APPLICATION NO.	FILING DATE	FIRST NAMED INVENTOR	ATTORNEY DOCKET NO.	CONFIRMATION NO.
10/658,302	09/09/2003	William Shelmon	TTC-13002/08	2137
25006	7590	06/07/2006	EXAMINER	
GIFFORD, KRASS, GROH, SPRINKLE & CITKOWSKI, P.C PO BOX 7021 TROY, MI 48007-7021			LARSON, JUSTIN MATTHEW	
			ART UNIT	PAPER NUMBER
			3727	
DATE MAILED: 06/07/2006

Office Action Summary

DETAILED ACTION

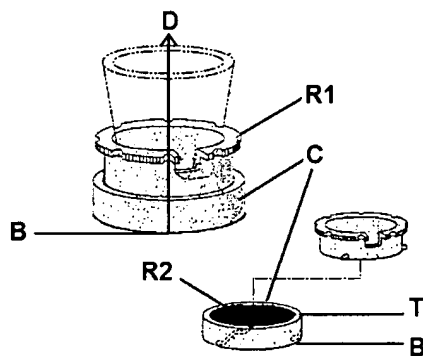
Regarding the newly added limitations to claims 1, 6, and 10, Examiner provides the following Figure and explanations:

Regarding the limitation "said at least one recessed portion extending between a top end and an opposite bottom end of said carrier portion", in the above figure, the recessed portion (R2) of Dennis et al. clearly extends between a top end (T) and a bottom end (B) of the carrier portion (C).

Regarding the limitation "said receptor portion protruding axially outwardly relative to said bottom end while in said extended position", in the above figure, the

receptor portion (R1) of Dennis et al. clearly extends in a direction (D) out of the carrier portion (C), the direction being upward and outward from the carrier (C) relative to the bottom (B) of the carrier (C).

FIG. 7

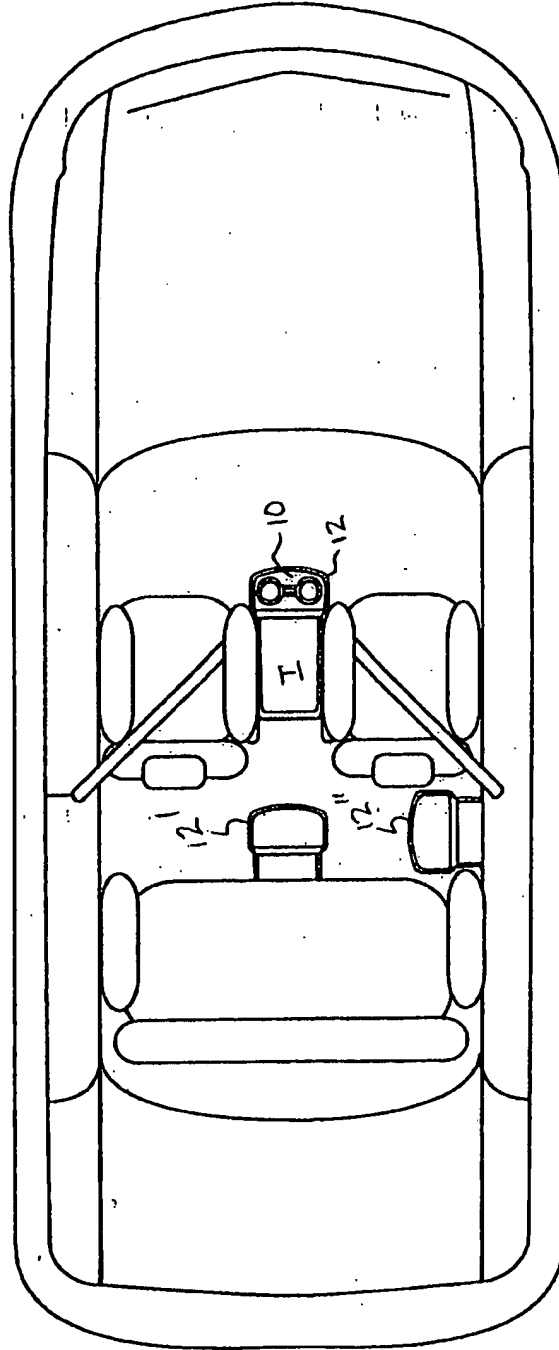
1. The drawings were received on 3/2/06. These drawings are not approved because Figure 7 contains New Matter. Figure 7 shows specific locations of the container holder within the vehicle that were not specifically mentioned in the originally filed disclosure.

NOT APPROVED JML 5/30/06
